26 Netherhall Gardens

Basement Impact Assessment
Audit

For
London Borough of Camden

Project Number: 12985-51
Revision: F3

TITLE: Site Sketch Plan

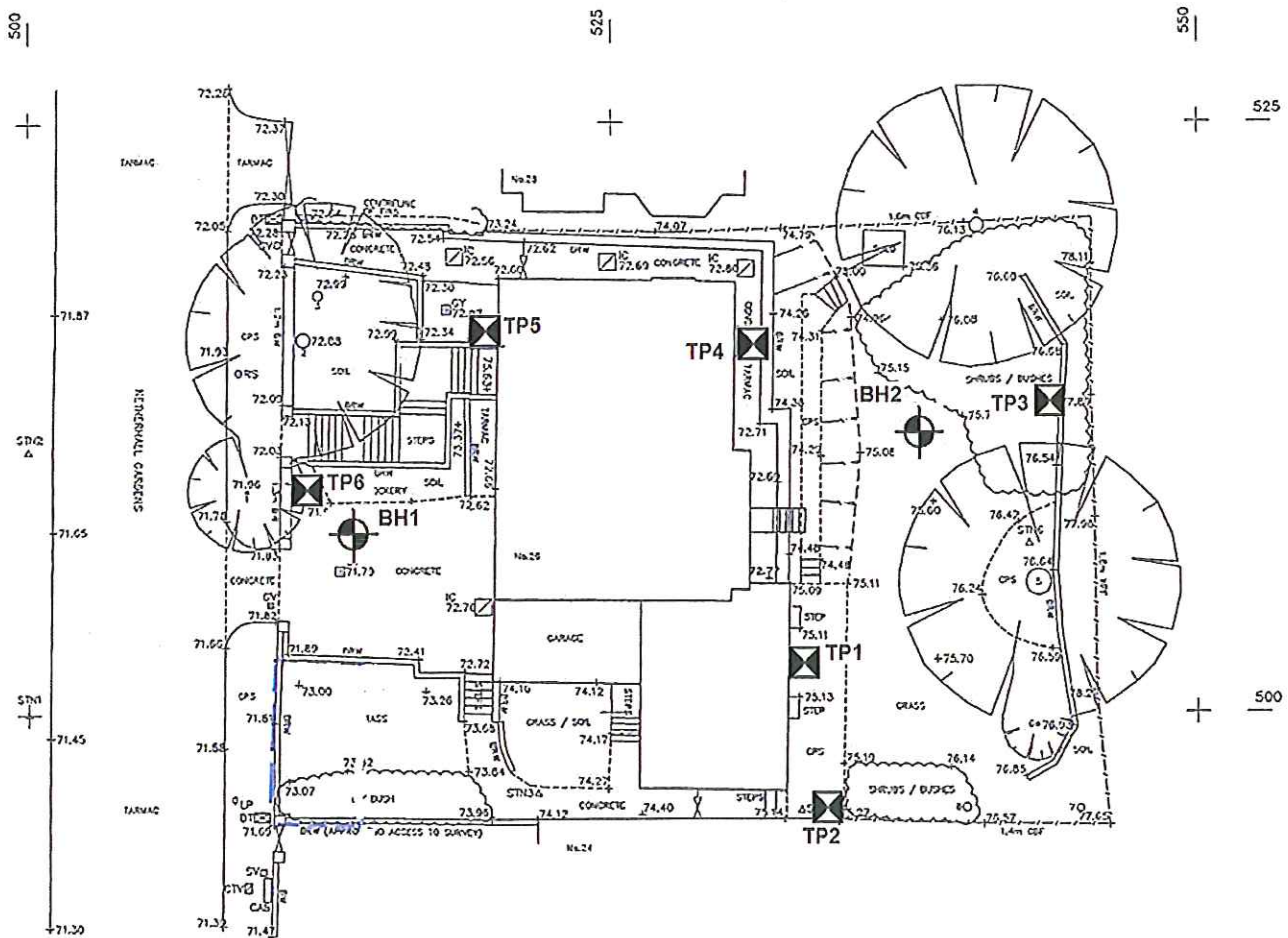
As part of the SI, a trial pit was excavated to the 24A NG extension building (TP2), please refer to Appendix A of this File Note where the Trial Pit Location Plan has been provided as well as the subject trial pit section sketches. TP2 was excavated to a depth of 1.5m which was still within the Made Ground, however, the underside of the foundation was not discovered, although the top of the mass concrete base had. TP1, a trial pit located approximately 5-6m away was also excavated to 1.5m depth, this trial pit struck the clay at a depth of 1.38m from a similar ground level. Based on the proximity of TP1 to TP2, the clay layer being close and the fact that 24A NG foundations go deeper suggests that the foundations to 24A NG are in fact founded within the clay layer. It is acknowledged, as it is in the 'Heath & Hampstead
